BZA Application Form

BZA Number: 155114

LOCATION OF PROPERTY: 33 Webster Ave., Cambridge, MA

To increase the height of the building which will violate setback requirements.

① PROPOSED SOUTH ELEVATION - UNIT 33
1/4" = 1'-0"

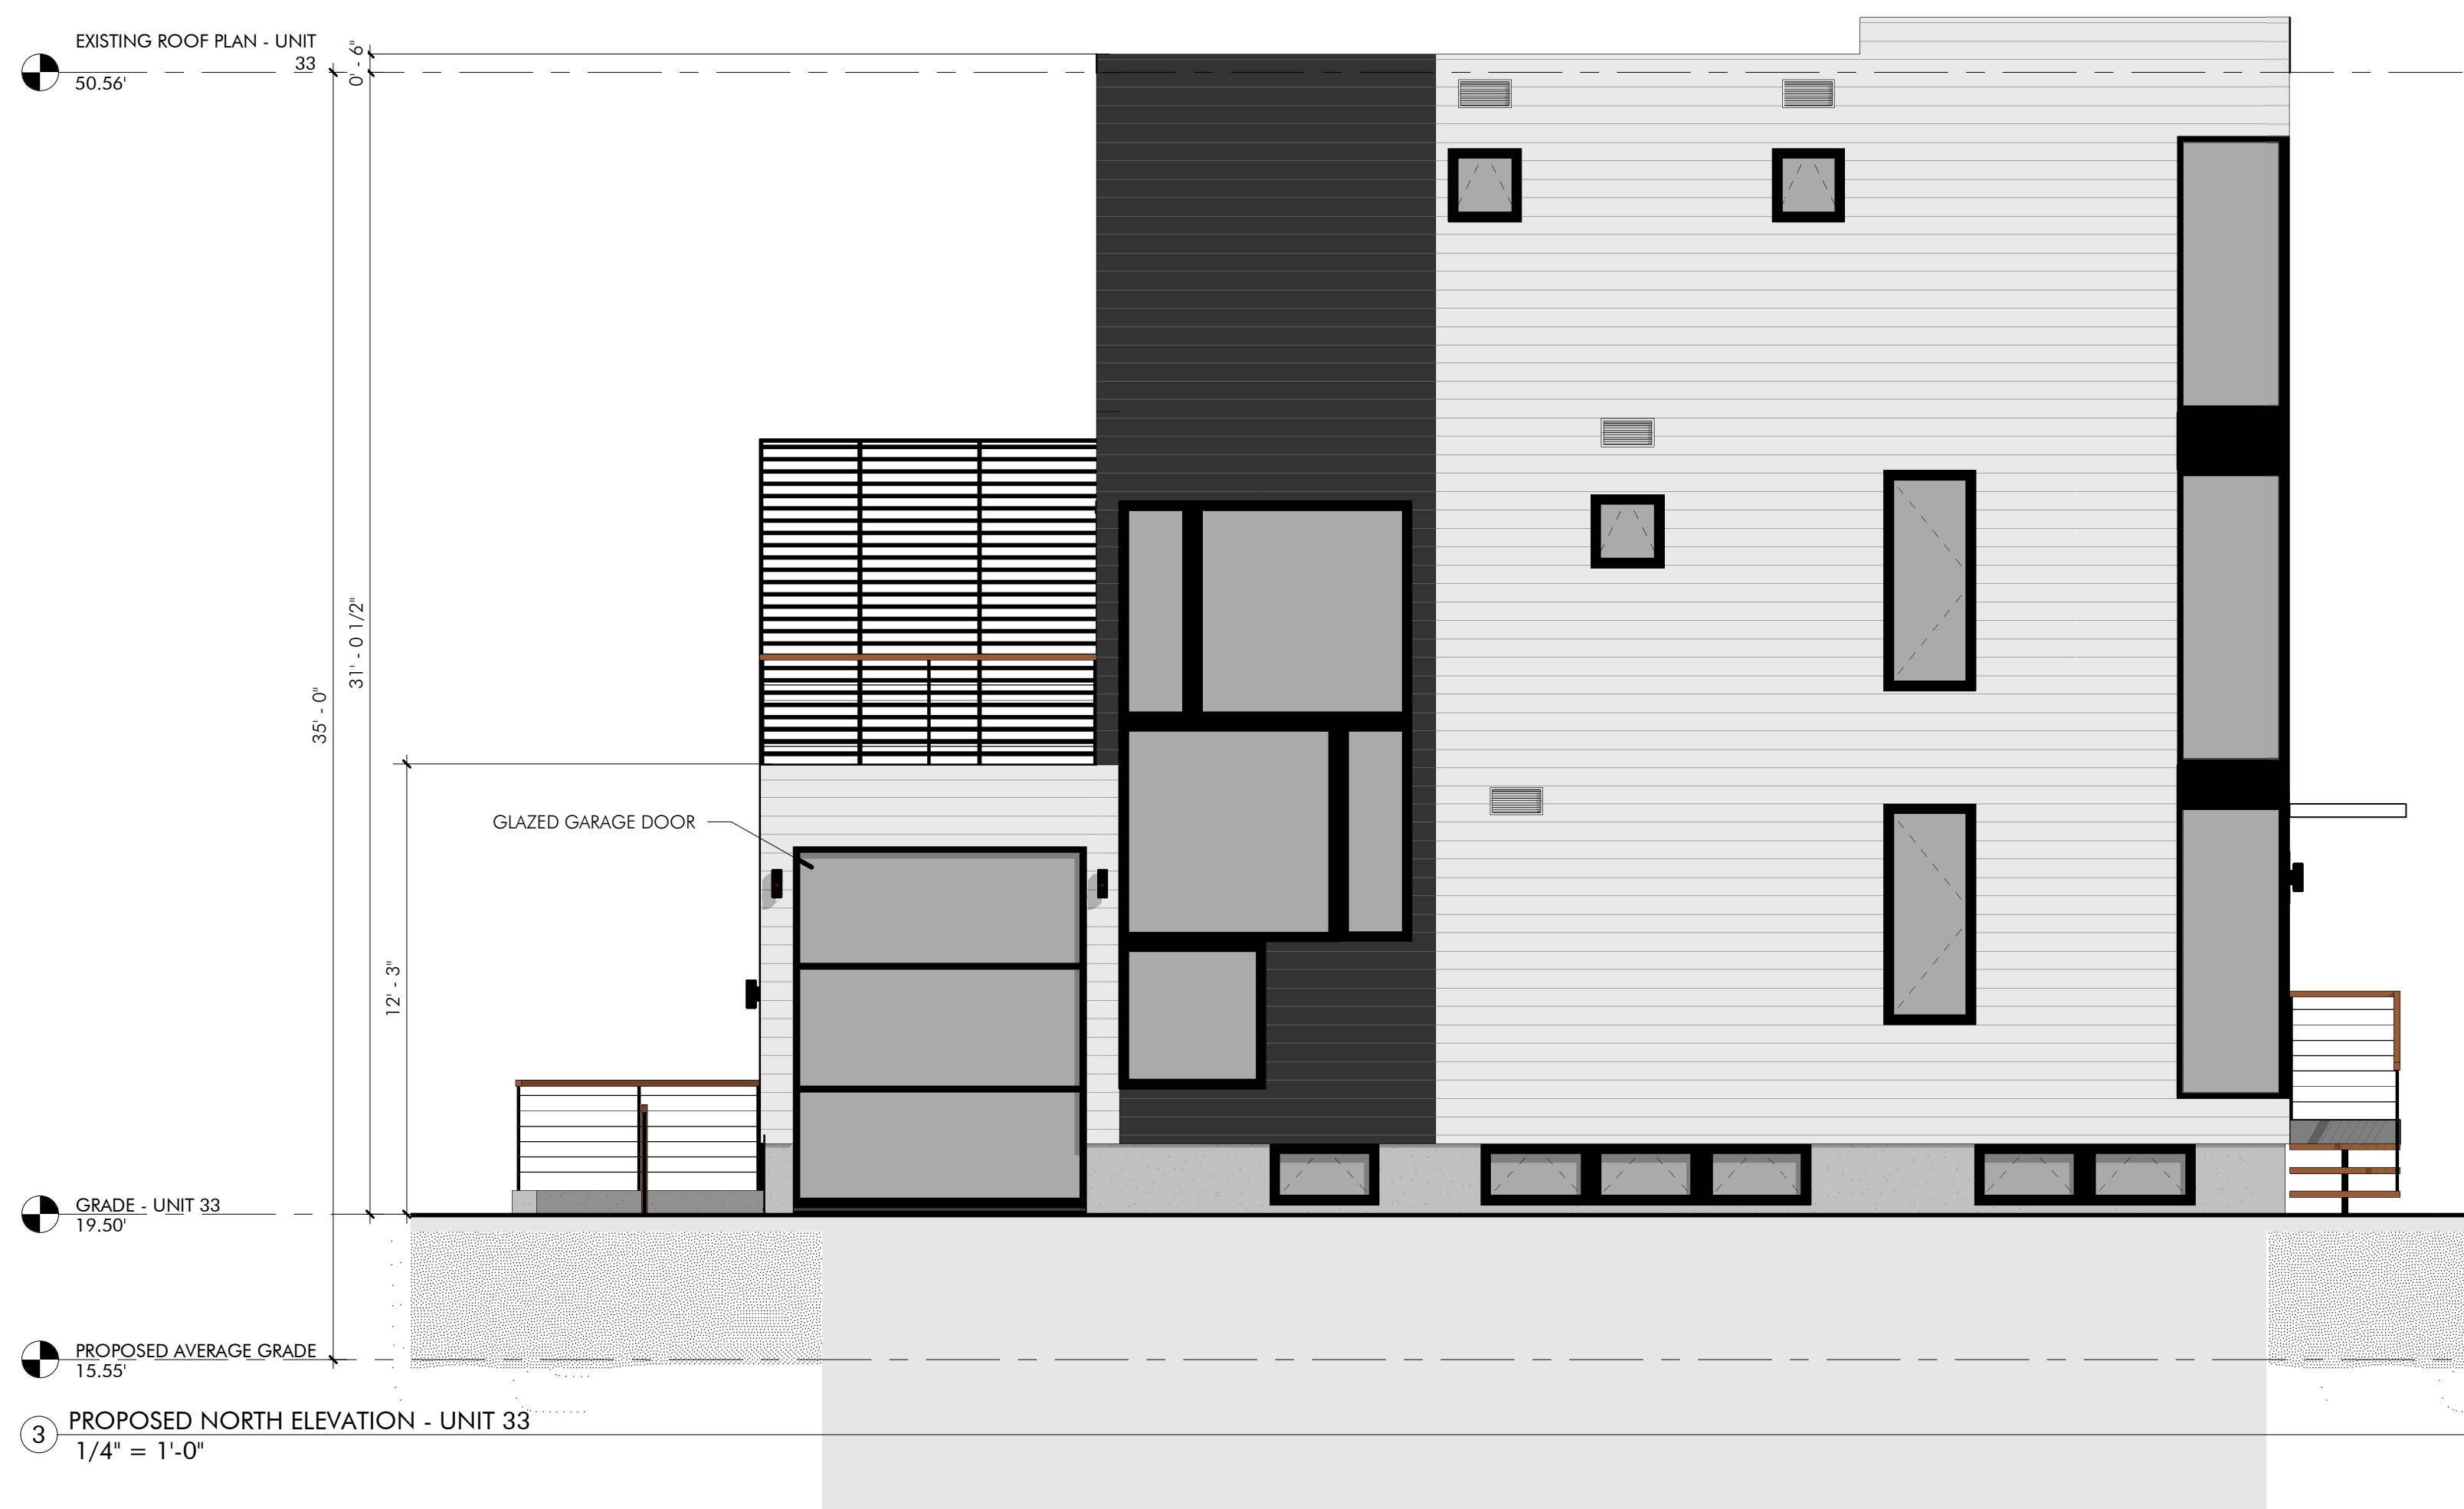
- The proposed SOUTH ELEVATION - UNIT 33 has a 2-story high attachment that acts like a 2-story fence. However, the installation of such an attachment fence poses security dangers to nearby units. In fact, this attachment fence was not present when the developer first presented his plan to us. Therefore, we are opposed to this attachment fence. Such an partially enclosed space is also not clearly defined to be excluded from the GROSS FLOOR AREA.

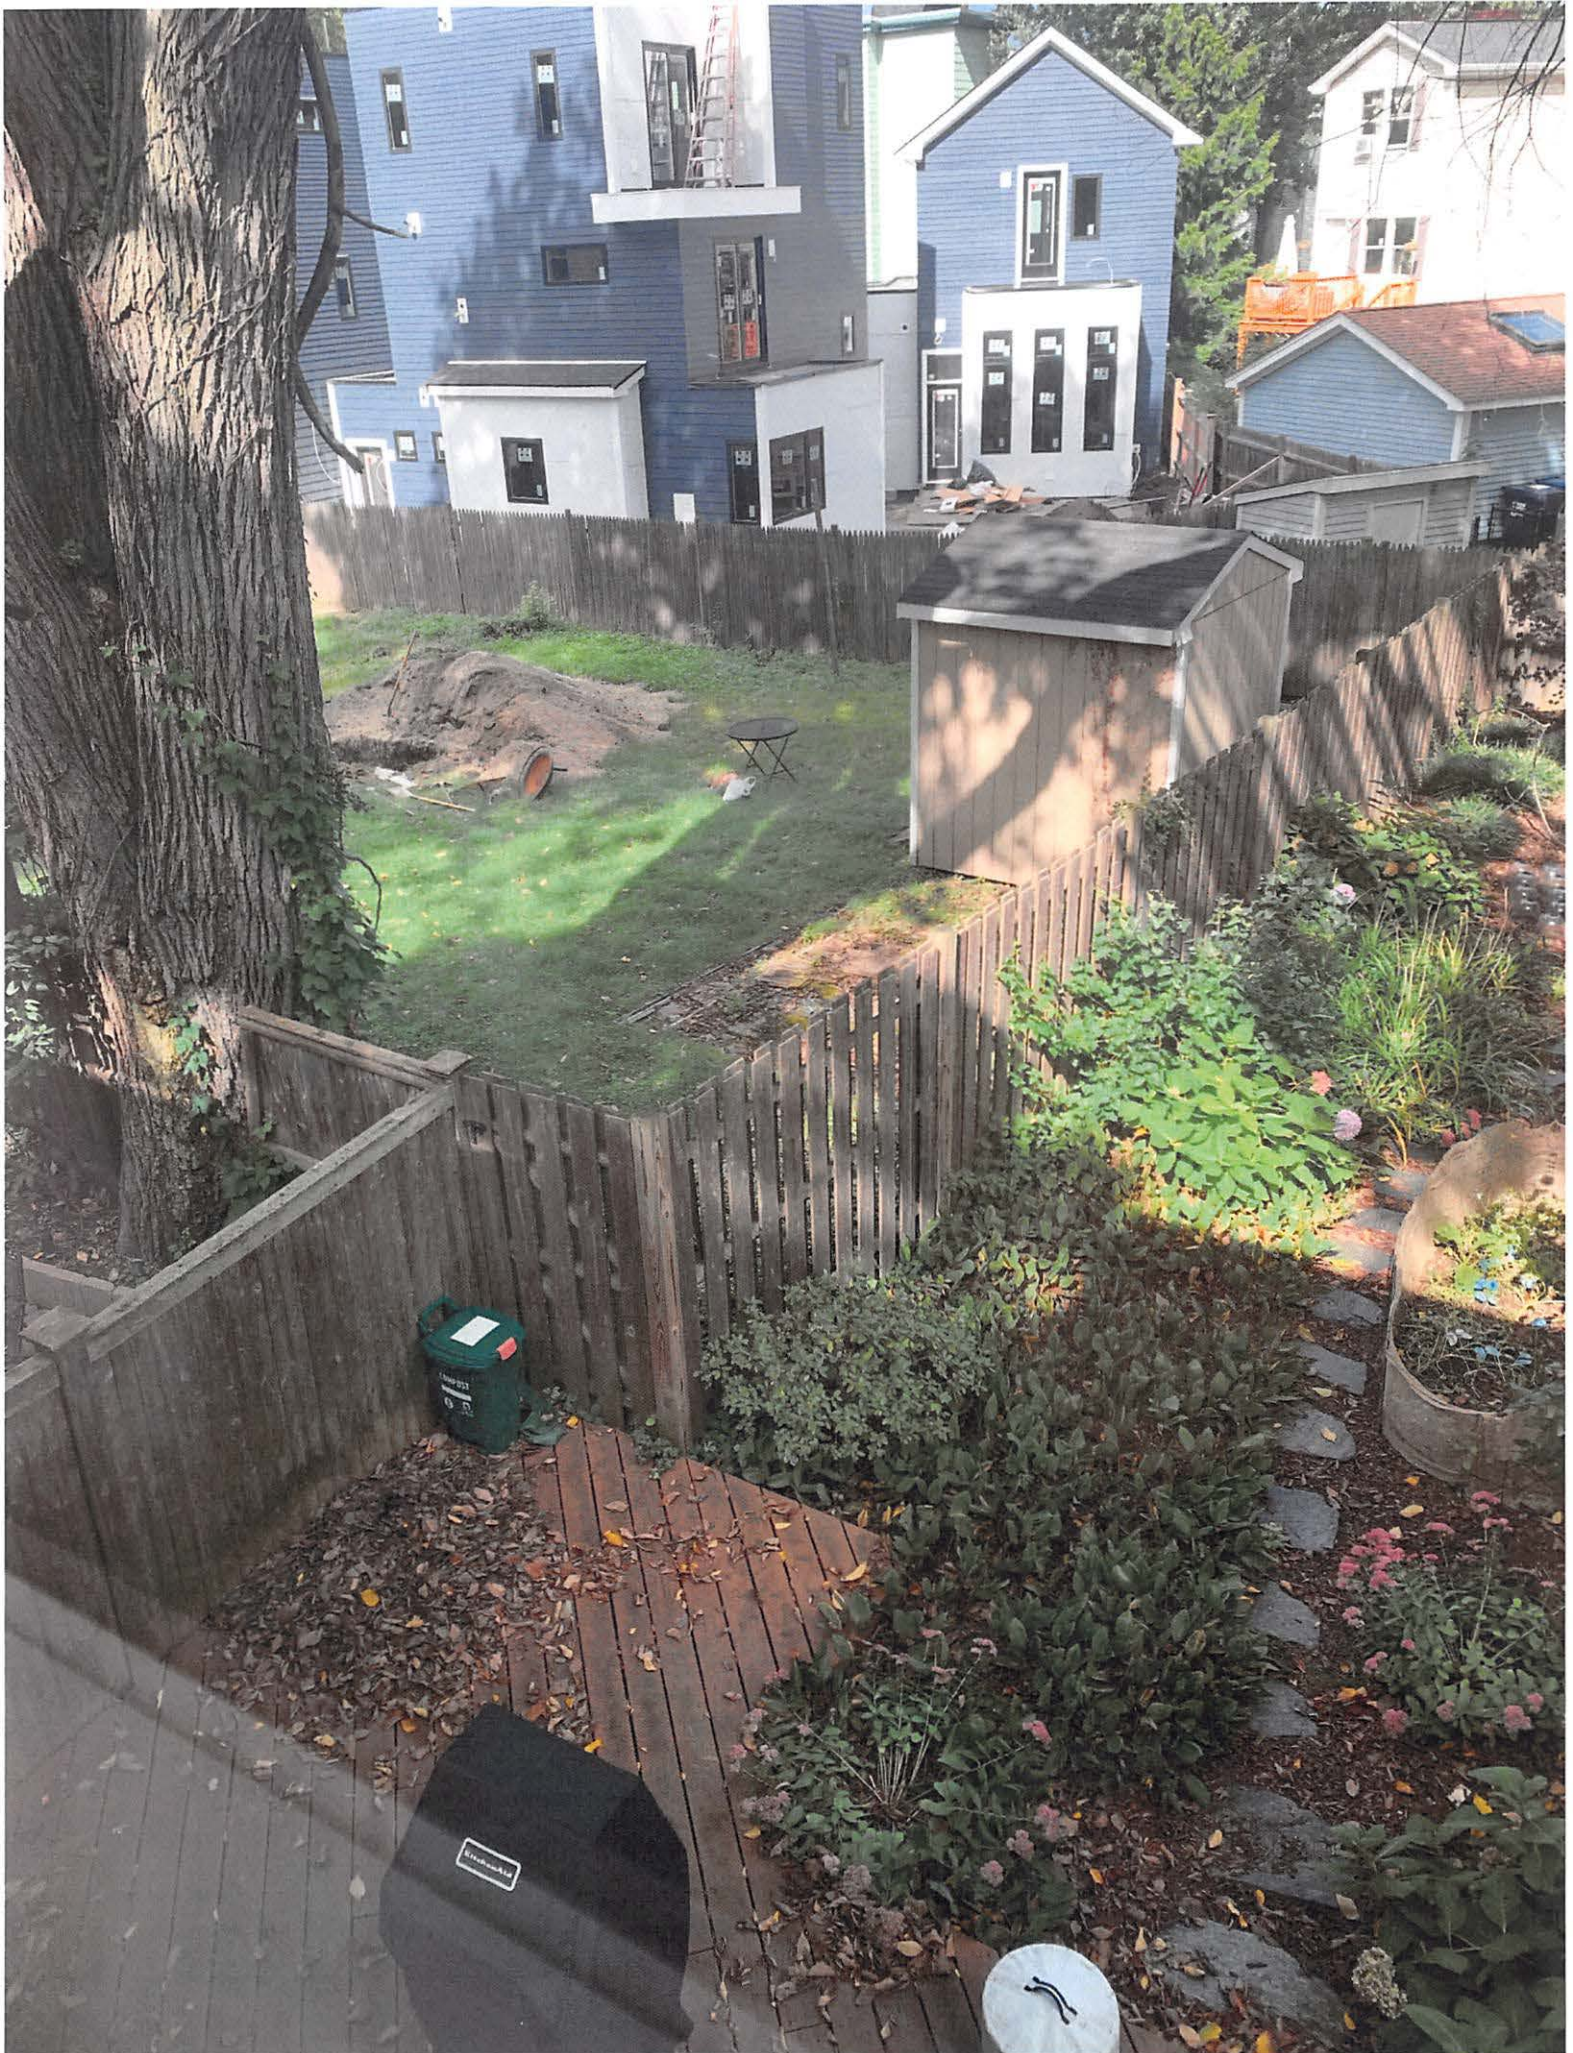
- Can we get an explanation on why the balcony is exempted from GROSS FLOOR AREA of Unit 37? The BZA application says that "3' MIN. CLEAR O.C. FOR STRUCTURAL ELEMENTS, PER 20.53", but 20.53 of the Zoning Ordinance does not have corresponding regulations.

Map showing location of the proposed construction relative to 5 Lilac Court

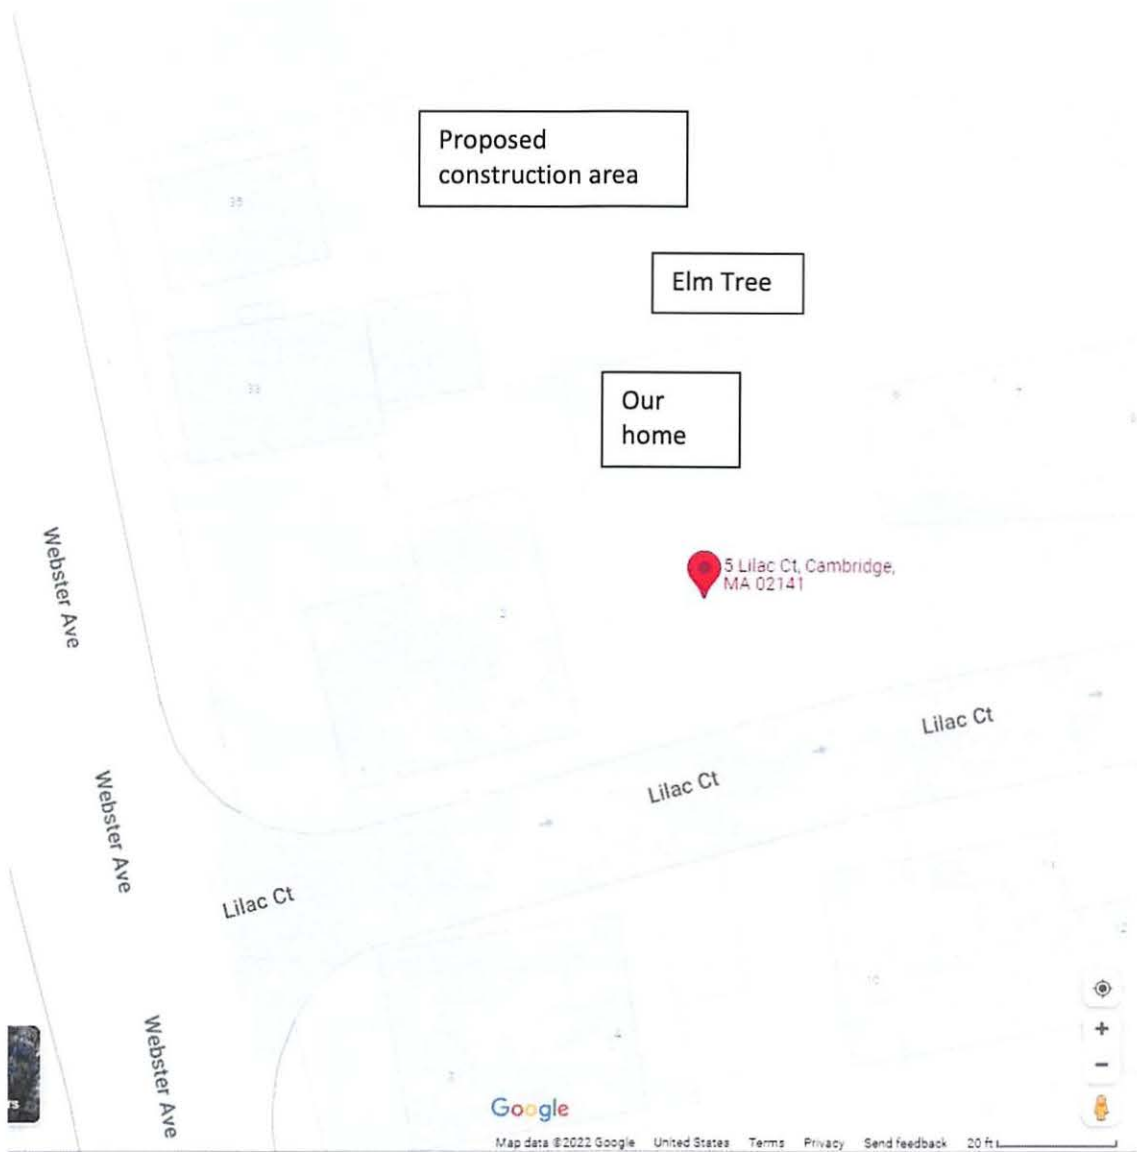
- The construction introduces meaningful risk to the large and rare American Elm tree that brings character to several of the abutting houses, including ours. If the tree and its roots are damaged by the construction and its survival is impeded by the necessary reduction in its root distribution, then the loss of the tree would be a preventable travesty to the community. There is reasonable justification for fear that the construction would have this predictable effect. The tree protection plan submitted by the applicant extends only one year, and the zoning board will have no capacity to hold the applicant accountable if he defaults on the submitted plan. A tree that does not survive this applicant's construction with its known and predictable risks to the roots and health of the tree could fall onto one of the local structures causing risk to persons and property if the application for an exception and variance is approved. What is more, any damage to the tree caused by the applicant's destruction might not be detectable for years.

Elevation view showing the impact of these large properties on the look and feel of the neighborhood, the view directly into our garden and house, and the impact on fair access to sunlight

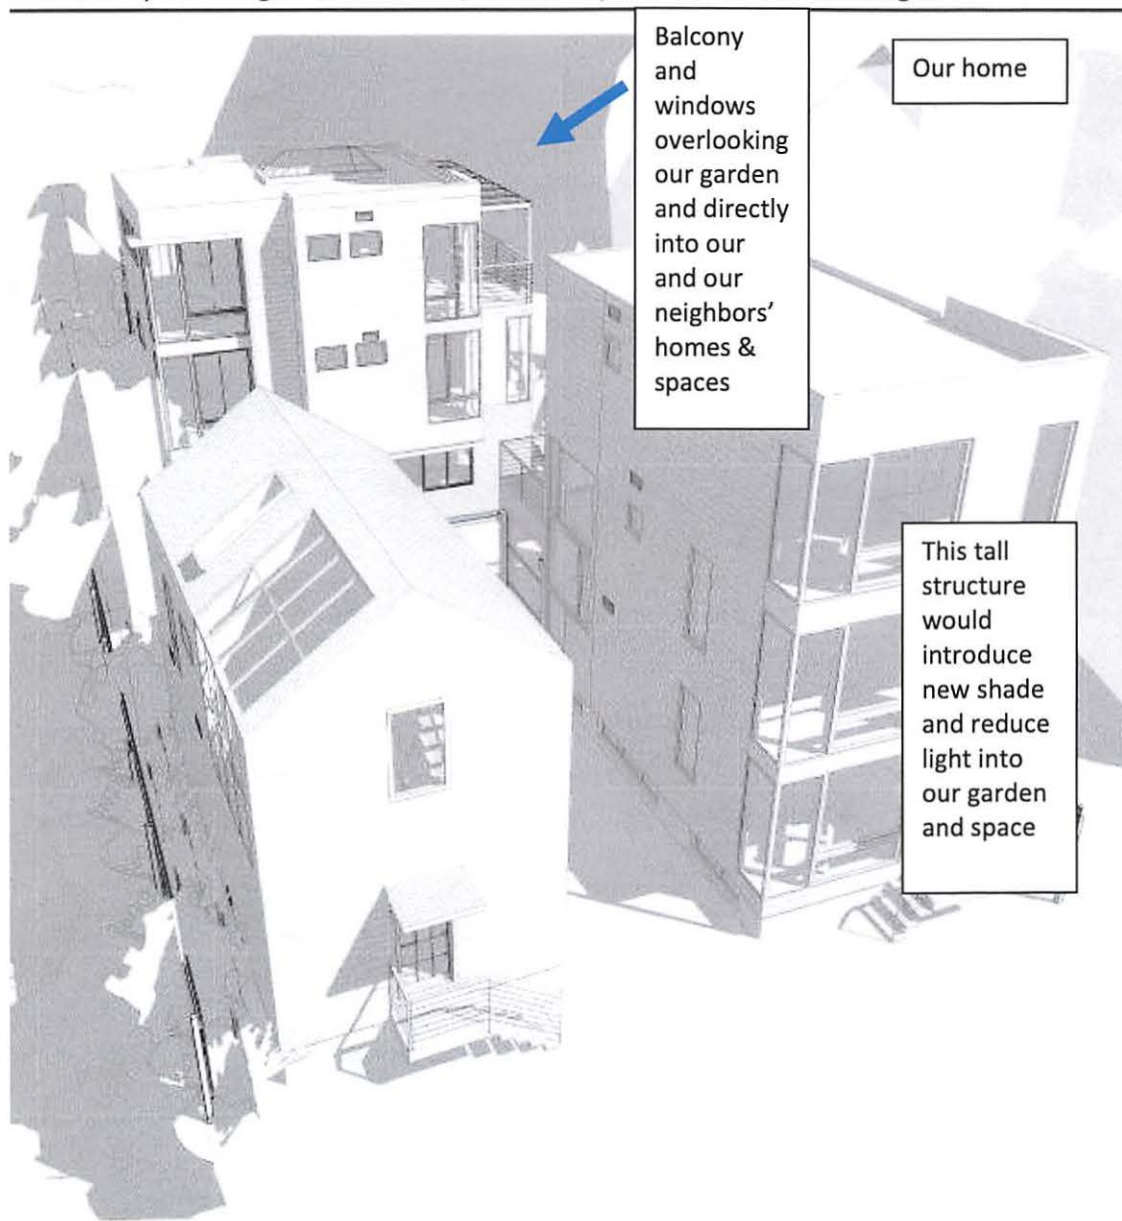
- There does not appear to be adequate justification to waive expectations that the applicant conforms with existing standards and precedents that guide the consistency, look and feel of the neighborhood.

Before and After view of impact of shade at one time point showing effect on sunlight into the gardens, to the tree and to the abutting properties

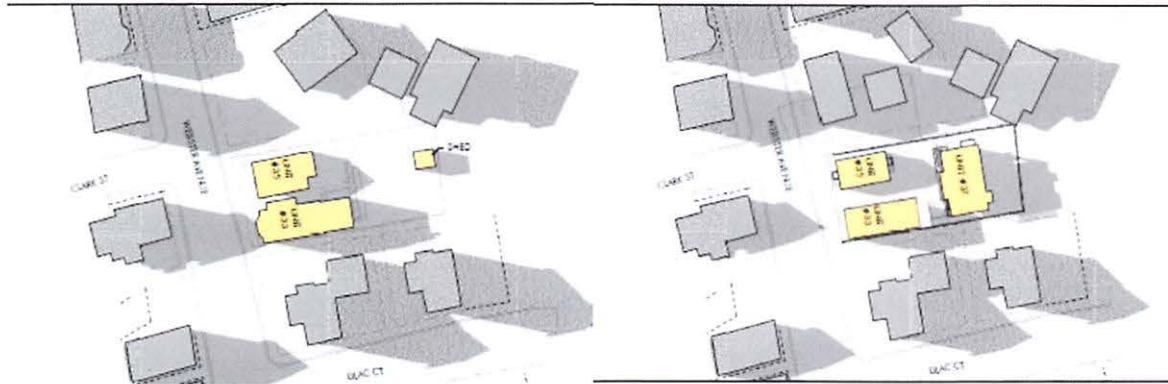
- The proposed plan will further diminish sunlight in the surrounding neighborhood due to the close proximity of buildings. From October to March every year, the main source of sunlight is from the south (see [sunlight analysis](#)), including south west and south east. The winter period is also when depression and seasonal affective disorder are most prevalent in the city filled with students and professionals with stressful lifestyles. Depression, especially seasonal affective disorder, can be directly caused by lack of sunlight. The construction of the new dwelling (referred to as UNIT 37 in the application) is **above the MAX. ALLOWABLE BUILDING HEIGHT** and will lead to a **daily loss of ~2 hours of sunlight** at our property.
